ECONOMIC COMMISSION FOR EUROPE

Eighty-fourth session

PROPOSALS FOR AMENDMENTS TO ANNEXES A AND B OF ADR

Proposal for amendment to text in document 2008/4 "Provisions for Mobile Explosives Manufacturing Units (MEMUs)" from the working group on MEMUs

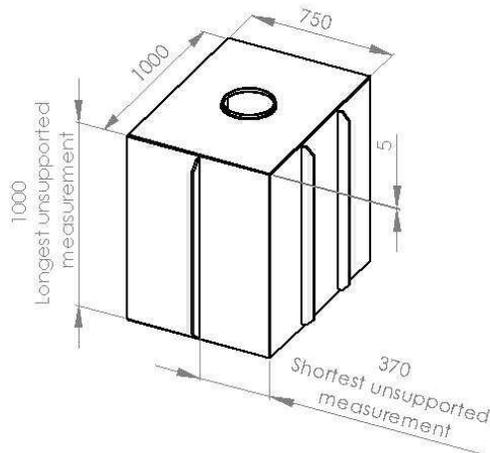
The word "SHORTEST" was during the last hour of the last meeting replaced by "LONGEST" as shown below.

6.12.3.2.4 Tanks may have constructional parts that are without a radius of convexity. The **longest** (~~shortest~~) non-supported measurement of such parts shall not be greater than 100 times the wall thickness. Such supportive measures may be curved walls, corrugated walls or ribs.

The illustration below is explaining the difference:

A tank with volume 750 litres is made of 5 mm plane plates.

100 x plate thickness = 500 mm.

A stiffening rib, located at the shortest non-supported measurement, 370 mm (< 500 mm) from each side gives sufficient support.

However, the longest non-supported measurement is 1000 mm!

When the text was originally written, the meaning was that the maximum distance between two parallel supports (ribs or bends in a corrugated wall) should be maximum 100 times the wall thickness. This should however only apply in one direction since this gives enough support.

There should not be any constraints to the distance in the other direction (the longest direction - parallel to the supports). This could make the tank difficult to make without giving any benefits.

6.12.3.2.4 Tanks may have constructional parts that are without a radius of convexity. **Alternative** supportive measures may be corrugated walls or ribs. **In at least one direction the distance between parallel supports shall not be greater than 100 times the wall thickness.**

6.12.3.2.4 Tanks may have constructional parts that are without a radius of convexity. The longest non-supported measurement *in at least one direction* of such parts shall not be greater than 100 times the wall thickness. Such supportive measures may be curved walls, corrugated walls or ribs.

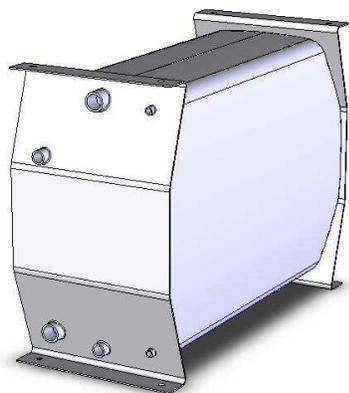
This figure shows how a small tank with curved walls and corrugated ends typically could look.

The change of wording is most important for the corrugated ends on this figure. It is only possible to bend a plate in one direction at the time.
